640 Lampson Street – Front Doors Path Access Variance

April 13, 2026

FRONT DOOR ACCESS REVIEW

APPLICATION AS SUBMITTED – NOV 12 2024

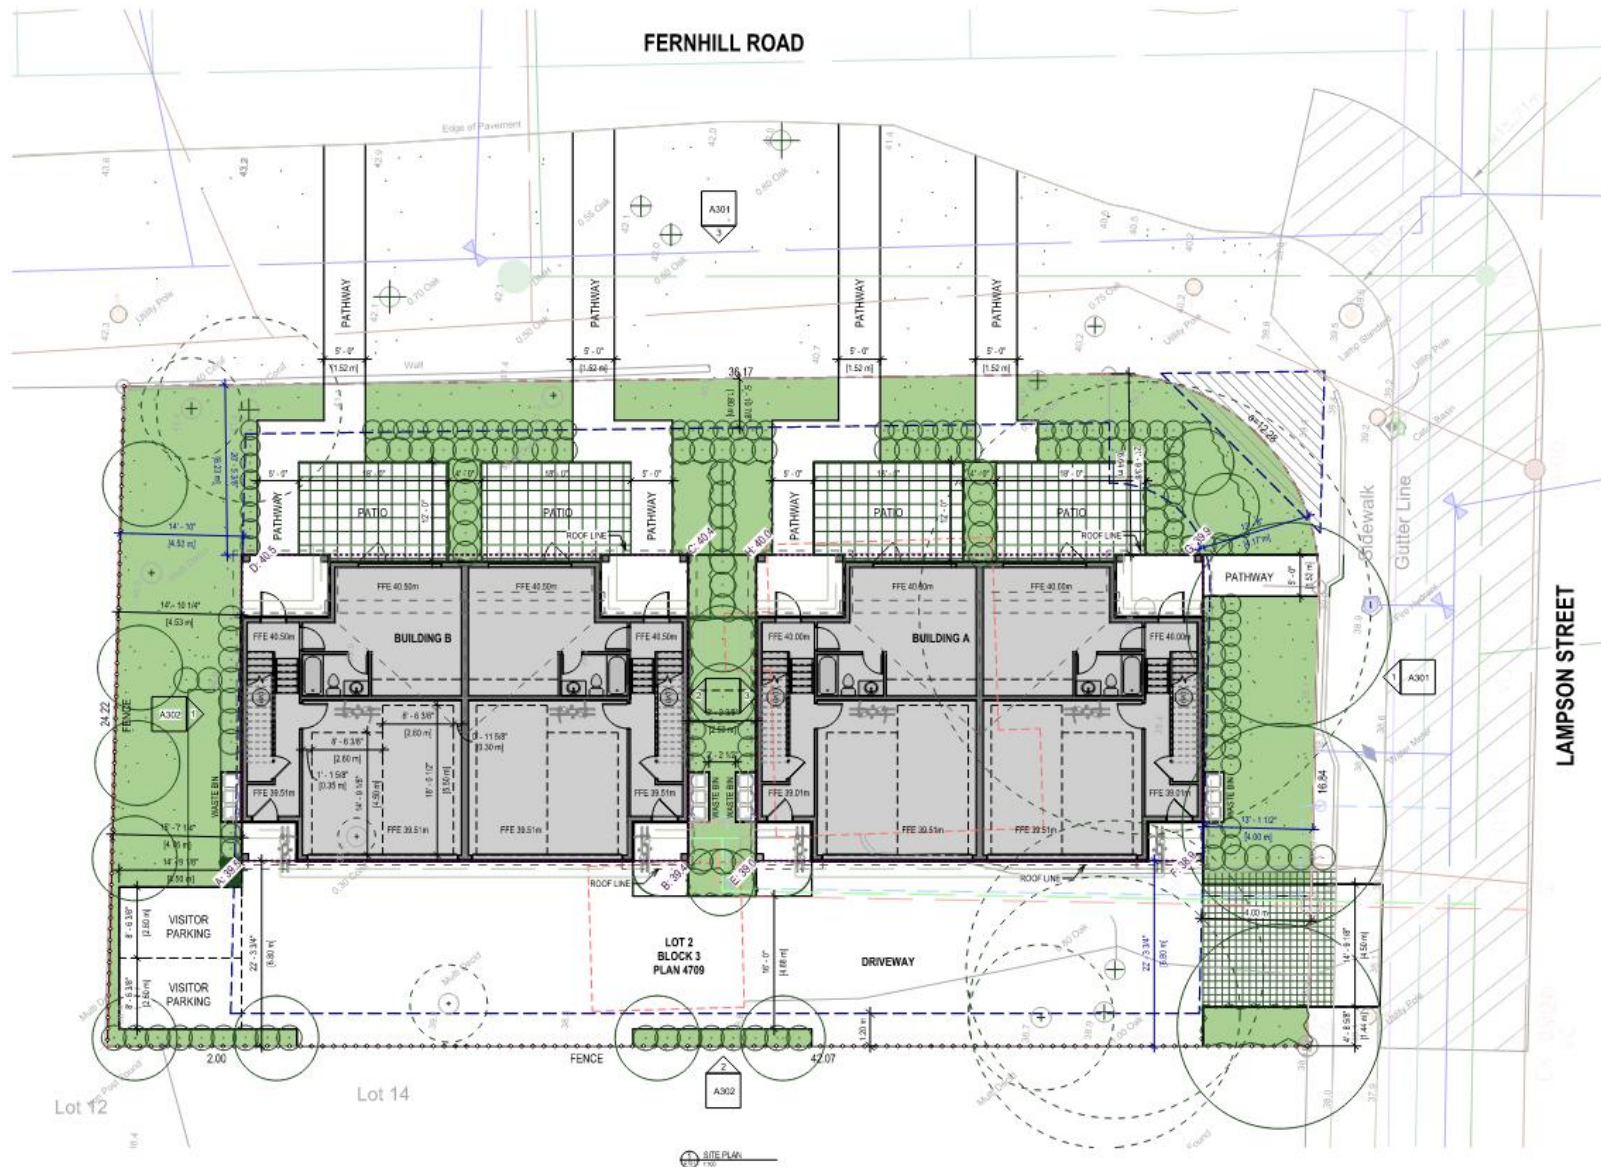
640 Lampson DP000240 Initial Comments

2. Staff has been considering 6m x 6m to be a standard minimum useable open space. The open space in the side yard on the west side of the property has a width between 4.5m and 4.75m. Please consider trying to expand this space to 6m in width.

3. Ideally the east building should be designed to address both frontages.
4. The gap between the two buildings is awkwardly narrow when considering the bins narrow the space to a 1m gap on the architectural drawing.

5. The landscape plan is different from the architectural in the building gap, with the bins on the one side and planters on the other. Please ensure that the landscape and architectural drawings are consistent.

6. This space is not ideal from a CPTED perspective. Between the bins/planters and the trees the sight lines are poor, there is limited defensible space, no indication of lighting in that space and there are limited eyes on that space from either building due to the sharp angle from the 2nd/3rd storey windows.

7. The windows on the interior elevations of the buildings are directly aligned, limiting privacy for each residence. On the one hand, frosting the windows would improve privacy. On the other, they are the only overlook for the space between the buildings.

8. The two trees planned for the gap between the buildings will likely be cramped, difficult to maintain and receive limited light. Furthermore, they limit sight lines and create indefensible space for people using the bins.

9. The space between the buildings should offer a 'pleasant pedestrian pathway'. Suggest moving the trees and ensuring that there is no 1m gap between two sets of bins.

- 0.85m road dedication along Lampson is not shown.
- Storm water management, so the post construction flows do not exceed preconstruction flows, to be shown on servicing plan.
- Underground Hydro/Tel/Cable to the proposed development to be shown on servicing plan.
- Not supportive of the proposed pathways going through trees onto Fernhill Road.
- Access to units on north side should be as illustrated.

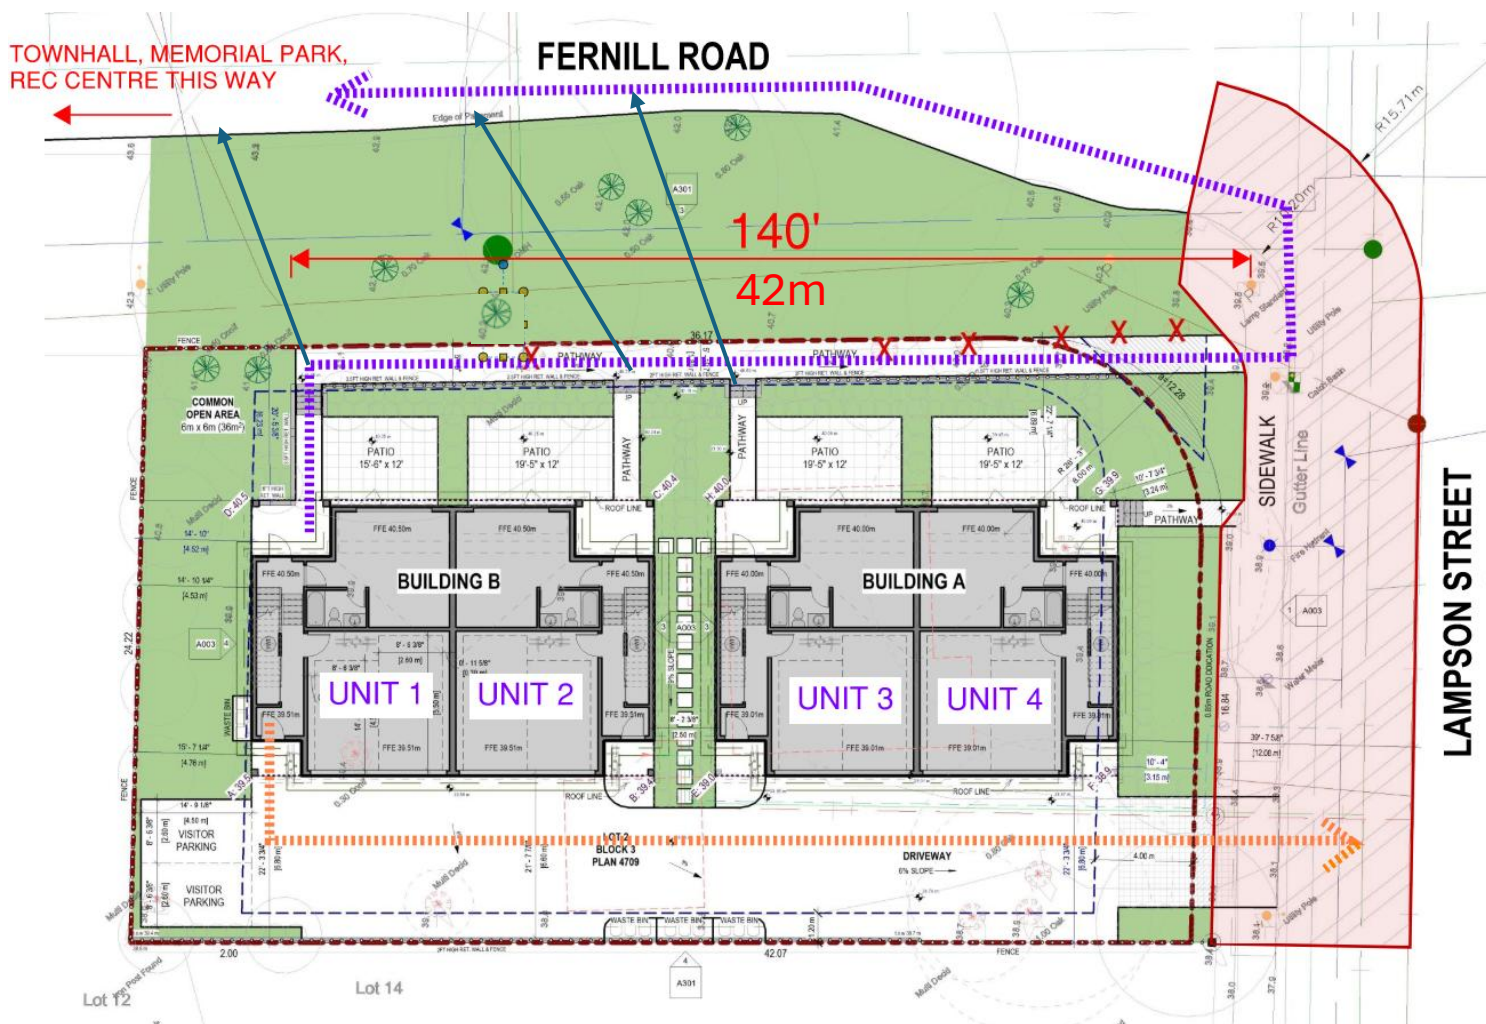
1. No sidewalk along Fernhill Rd, only on Lampson, therefore it is safer to connect to Lampson
2. Grade change is significant
3. Garry Oak roots health potentially compromised

1. Front-door function is compromised

Some residents would need to walk extra 140' to reach Lampson, and 140' back every time they leave their home to reach their front door if they are approaching/going from the west.

Non-residents/visitors/deliveries will have a hard time locating these entrances, especially at night time and in emergencies

2. Privacy of the green spaces is compromised

Requested internal pathway (in purple) would run directly through the spaces intended to be private outdoor areas for each unit. With driveway requested to be from Lampson at the rear of the units, and this pedestrian path in the front, private green space is essentially impossible to achieve for this development (on a 12,000sf lot that is not overbuilt this should not be the case.)

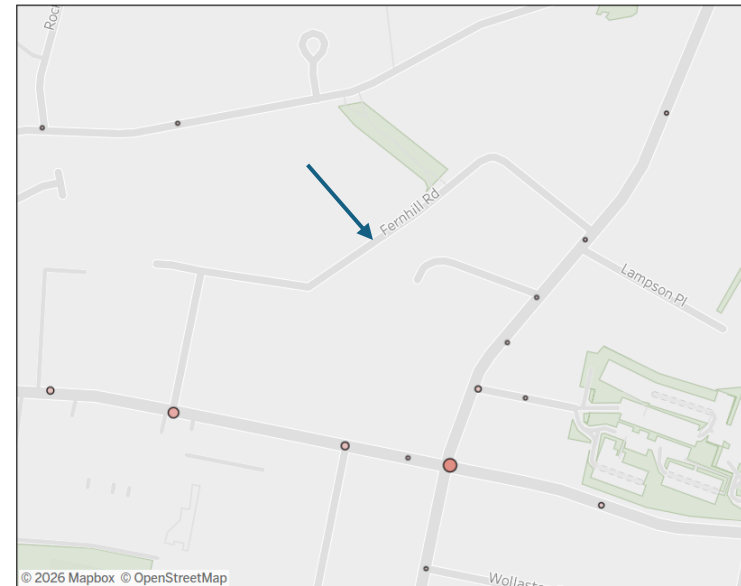
3. Results in removal of more trees

The pathway as requested by the Township results in the loss of 7 additional trees on site (marked with red X) than otherwise would happen. Pathways as proposed directly to Fernhill allow these 7 trees to remain.

667 FERNHILL (NEXT DOOR) HAS TWO ACCESS POINTS TO FERNHILL

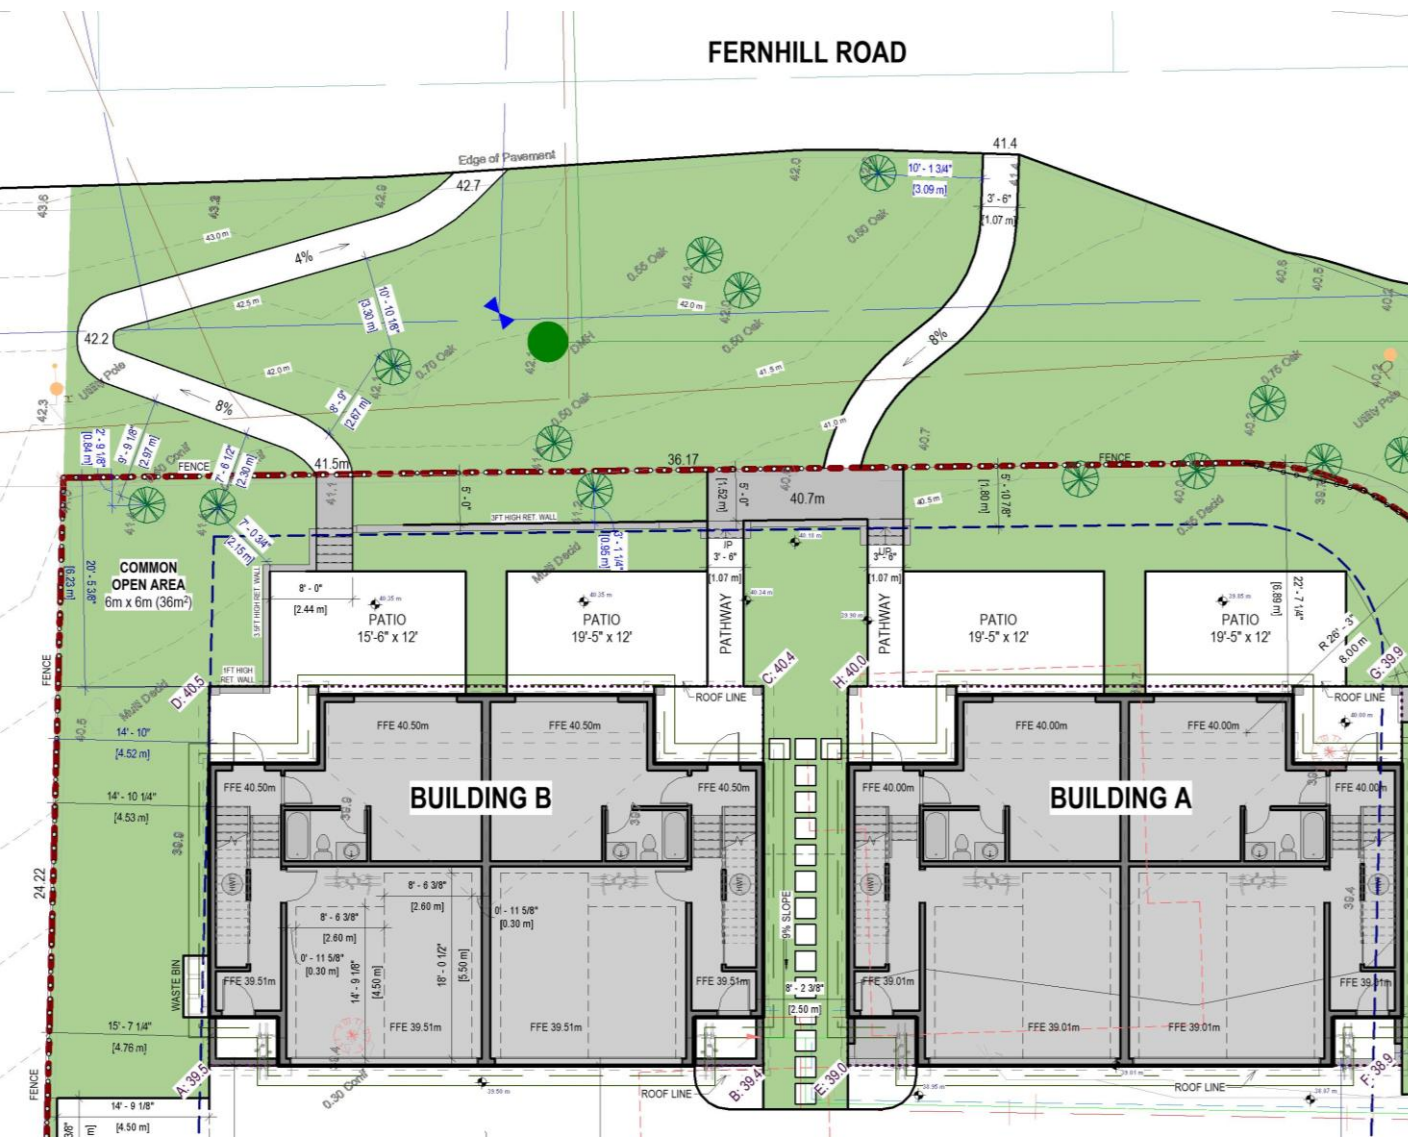
1. *No sidewalk along Fernhill Rd, only on Lampson, therefore it is safer to connect to Lampson.*
 - Fernhill Rd has slower traffic due to narrow profile and turns.
 - No parking on either side with good visibility & no accidents when compared to multiple other no sidewalk streets in Esquimalt
 - Sharing the road is the norm here.

- All other properties on Fernhill without exception connect to it without sidewalk & function just fine, including newer multifamily projects. Some properties have 2 access points/paths per lot, like 667 Fernhill.
